VILLAGE OF EVENDALE

RE: Village of Evendale's Response to the Ohio Power Board Staff Report
On Duke Energy Central Corridor Pipeline Expansion Project
Case No. 16-253-GA-BTX

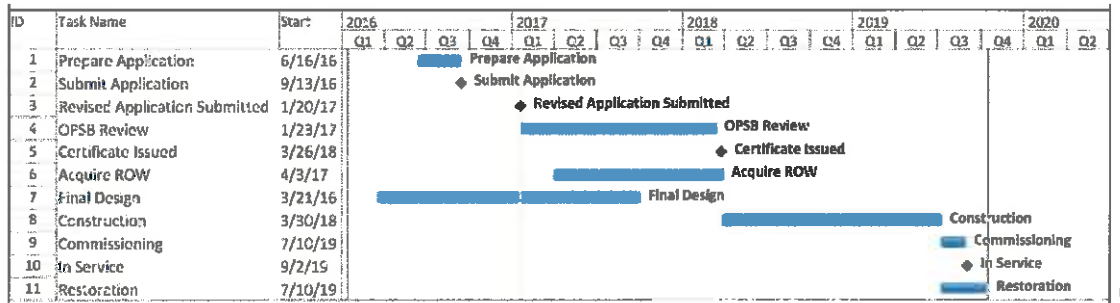
On Page 3-11 of the Duke proposal, the schedule for the project indicates that restoration will not occur until after the pipeline is installed along the entire project. We understand the need to let the trench settle, but a reasonable amount of time should be employed, so that portions of the properties remain unrestored up to 12-16 months. Furthermore, there are no guidelines on restoration of the affected sites. It should be incumbent upon the installer to ensure that the restoration is completed as weather permits and that any restoration work ensures that the property is back to original conditions.

In addition, in none of the amended submittals by the applicant has the project schedule been updated. With the delays of the application process the communities should be aware of the timing of the work.

Condition – The OPSB should require an updated time schedule.

CONDITION – The restoration shall be performed with 30 days of installation. In addition, the contractor shall be responsible for repairs on the trench and seeding for up to one year after approval of the project.
